CITY OF ROANOKE, TEXAS

ORDINANCE NO. 2023-122

Exhibit A

**Recommended Amendments to the
2021 International Residential Code**
North Central Texas Council of Governments Region

****Figure R602.6.1; delete the figure and insert the following figure:**

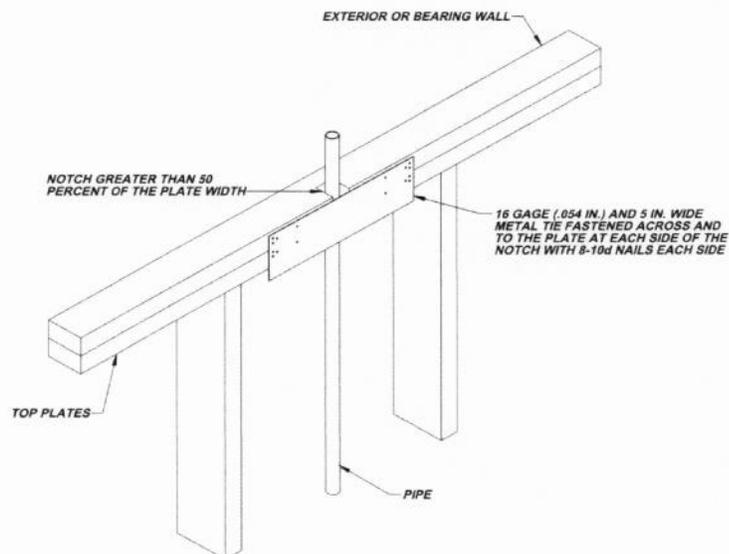
****Section R602.6.1; amend the following:**

R602.6.1 Drilling and notching of top plate. When piping or ductwork is placed in or partly in an exterior wall or interior load-bearing wall, necessitating cutting, drilling or notching of the top plate by more than 50 percent of its width, a galvanized metal tie not less than 0.054 inch thick (1.37 mm) (16 Ga) and ~~4 ½ inches (38) mm~~ 5 inches (127 mm) wide shall be fastened across and to the plate at each side of the opening with not less than eight 10d (0.148 inch diameter) having a minimum length of 1 ½ inches (38 mm) at each side or equivalent. Fasteners will be offset to prevent splitting of the top plate material. The metal tie must extend a minimum of 6 inches past the opening. See figure R602.6.1. *{remainder unchanged}*

(Amendment to 2015 IRC carried forward to 2018 IRC also provides additional assurance of maintaining the integrity of the framing by spreading the nailing pattern.)
